**DEPARTMENT OF TRANSPORTATION****Federal Aviation Administration****14 CFR Part 39**

[Docket No. FAA-2025-0618; Project Identifier AD-2024-00637-T; Amendment 39-23280; AD 2026-05-07]

**Airworthiness Directives; The Boeing Company Airplanes**

**ACTION:** Final rule.

**Figure 1 to Paragraph (h)(4)—Cap Seal Minimum Thickness (All Dimensions in Inches)**

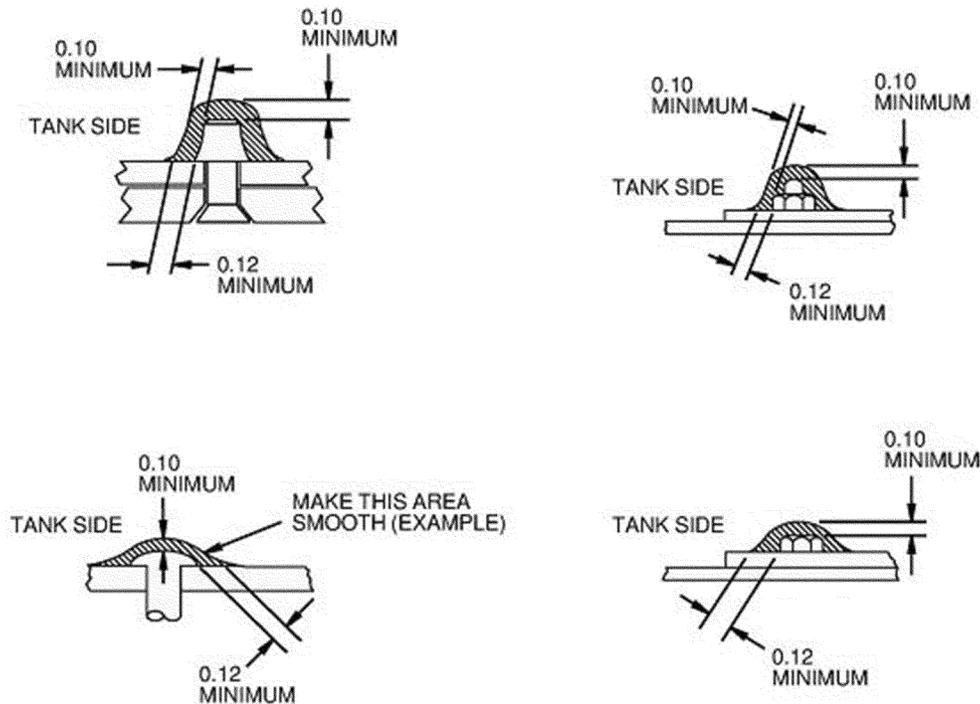
Boeing requested that the FAA remove paragraph (h)(3) and figure 1 from the proposed AD. Boeing stated Boeing Alert Requirements Bulletin 767-57A0148 RB, dated October 10, 2024, refers to section 28-11-00 of the 767 Aircraft Maintenance Manual (AMM) (*i.e.*, 767 AMM 28-11-00) for the cap sealing procedure, and the AMM contains the same cap seal minimum thickness specified in figure 1 to paragraph (h)(3) of the proposed AD. Boeing asserted that deleting the proposed requirement would prevent duplication of data and potential questions from operators.

Alternatively, Boeing requested the FAA revise paragraph (h)(3) of the proposed AD to clarify that the requirement applies to in-tank fastener cap sealing only and add a note to refer to 767 AMM 28-11-00 as an acceptable cap sealing procedure for in-tank fasteners. Boeing stated this clarification would prevent potential questions from operators and eliminate conflicting cap sealing requirements for out-of-tank fasteners.

FedEx requested that the FAA remove figure 1 and revise paragraph (h)(3) of the proposed AD to require application of the cap seals to wing tank fasteners internally, in accordance with section 51-20-05 of the 767 Structural Repair Manual (SRM) (*i.e.*, 767 SRM 51-20-05). FedEx stated the exception in paragraph (h)(3) of the proposed AD would result in multiple requirements for cap sealing of fasteners internal to the fuel tank, depending on the task being worked. FedEx also stated that the exception is overly general and should be specific only to cap seals internal to the fuel tank. FedEx noted fasteners that penetrate the 767 fuel tank are subject to Critical Design Configuration Control Limitations (CDCCLs) to ensure the lightning, fault current, and hot short protection requirements of Airworthiness Limitation (AWL) 28-AWL-08 are met. FedEx also noted that AWL 28-AWL-08 specifies no additional FAA Oversight Office approval is required if the repair or alteration is accomplished using 767 SRM procedures.

The FAA agrees that the cap sealing requirement of paragraph (h)(4) of this AD (corresponding to paragraph (h)(3) of the proposed AD) does not apply to fasteners outside the fuel tank. Accordingly, the FAA has revised paragraph (h)(4) of this AD to clarify the requirement applies only to fasteners, fastener heads, and fastener threads and collars inside the fuel tank.

The FAA disagrees with Boeing's request to remove the exception or add a note to refer to 767 AMM 28-11-00 as an acceptable procedure for the cap sealing required for in-tank fasteners. Boeing Alert Requirements Bulletin 767-57A0148 RB, dated October 10, 2024, already refers to 767 AMM 28-11-00 as an acceptable procedure, so including such a note in this AD is unnecessary. Further, referencing material as an accepted procedure does not make the actions in the material mandatory. Therefore, the FAA has determined that the exception in paragraph (h)(4) is necessary to ensure the cap sealing procedures are enforceable.

As stated previously, the FAA agrees that the cap sealing requirement does not apply to fasteners outside the fuel tank and has revised paragraph (h)(4) of this AD accordingly. However, the FAA disagrees with the commenter's request to require that the cap sealing for in-tank fasteners be done in accordance with 767 SRM 51-20-05 because the SRM refers to 767 AMM 28-11-00 for sealing of fuel tank repairs. Referring to 767 AMM 28-11-00 does not make the actions in that material mandatory, and the FAA has determined that the requirements in paragraph (h)(4) of this AD must be accomplished. Further, the FAA disagrees that the exception will result in multiple requirements for cap sealing of fasteners internal to the fuel tank because the 767 AMM 28-11-00 contains the same procedures as the requirements of figure 1 to paragraph (h)(4) of this AD. The FAA has not changed the AD in this regard.

(4) During application of any cap seal to a fastener, fastener head, and fastener threads and collars inside the tank, as required by this AD, the cap seal must be applied with a thickness equal to or greater than the dimensions specified in figure 1 to paragraph (h)(4) of this AD.
